Part 21 (PAR)

PART 21 REPORT - DEFECTIVE MOTOR OPERATED POTENTIOMETER

Report No. 10CFR21-0117
Rev. 0: 06/09/17**10CFR21 REPORTING OF DEFECTS
AND NON-COMPLIANCE**

COMPONENT: Motor operated potentiometer without pre-position feature
P/Ns: 72-07900-100-ESI
2-04E-184-103-ESI
2-00G-009-002-ESI

Photo 1: Desired Return-to-Center Cam Arrangement

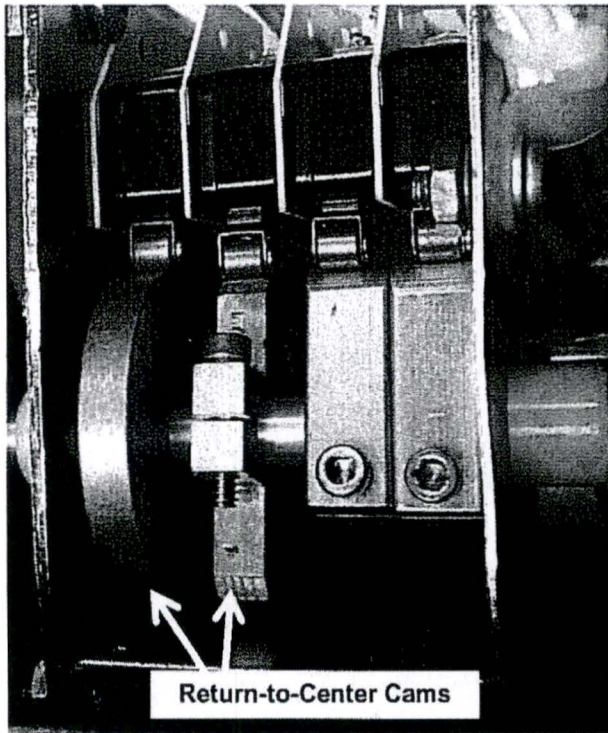
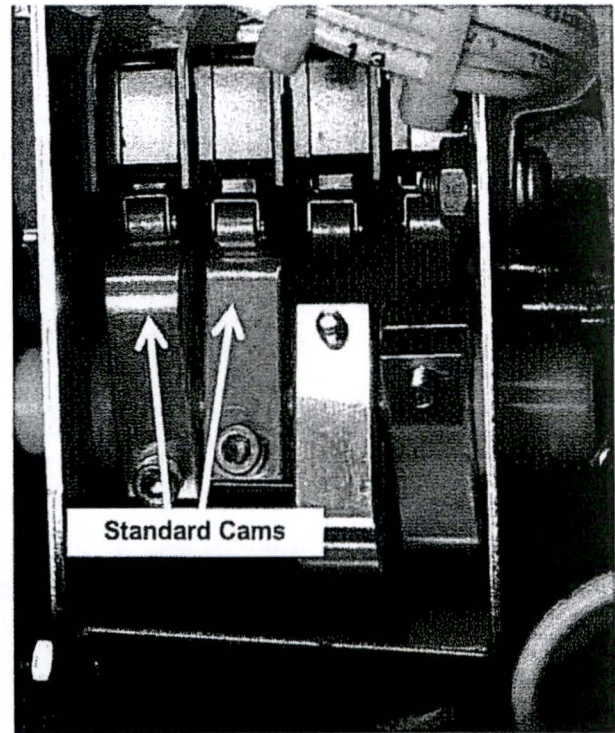
The Basler MOP selected by ESI for the assembly was model MOC2103. A review of Basler model MOC2103 indicates that it is not a return-to-center style device and instead contains a standard cam arrangement. Photos on the following page depict the differences between the two cam arrangement styles. ESI inadvertently selected the incorrect model for this application. Reviewing the qualification testing performed by ESI revealed that ESI's testing duplicated the original Portec test procedure (whereby one cam is set to close above setpoint and one cam is set to close below setpoint). However, the testing was shown to be inadequate to fully ensure the return-to-center functionality. Though the cams were properly set above and below setpoint, a further verification that the unit would return to center, even if sufficiently away from setpoint, was not performed. For installations that rely on the pre-position function, it is possible that the MOPs supplied by ESI would not return the potentiometer to setpoint. Since the MOP is used to set output voltage of the emergency diesel generator, the consequences of this issue are that the EDG may not maintain voltage within its required range to support its safety-related loads.

- To prevent recurrence of this issue, ESI is implementing a revision to the procurement process for this assembly to update the part number of the MOP utilized. In addition, the dedication inspection and testing activities are being revised to ensure testing properly validates the return-to-center feature. This action is currently underway and will be completed prior to any future shipments.

Photos 3&4: Return-to-Center Cam Profile & Arrangement

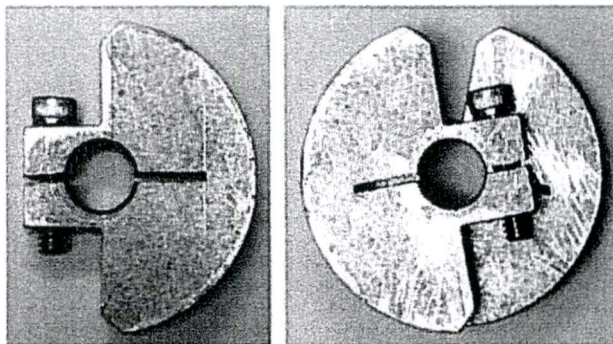
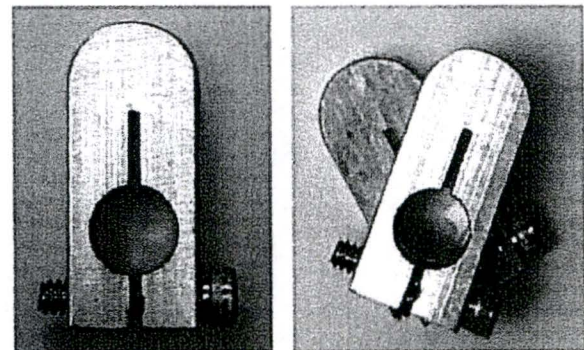
ESI selected the incorrect MOP to be used for this assembly. The original MOP used was an Portec/NEI P/N 72-07900-100 which became obsolete in the 1990s. ESI offered a replacement assembly (using the "-ESI" suffix) that included a Basler brand MOP, modified by replacing the factory supplied potentiometer to replicate the original Portec design. The original Portec MOP had the return-to-center feature and Basler offers some models with return-to-center and some without. ESI inadvertently selected the model without return-to-center.
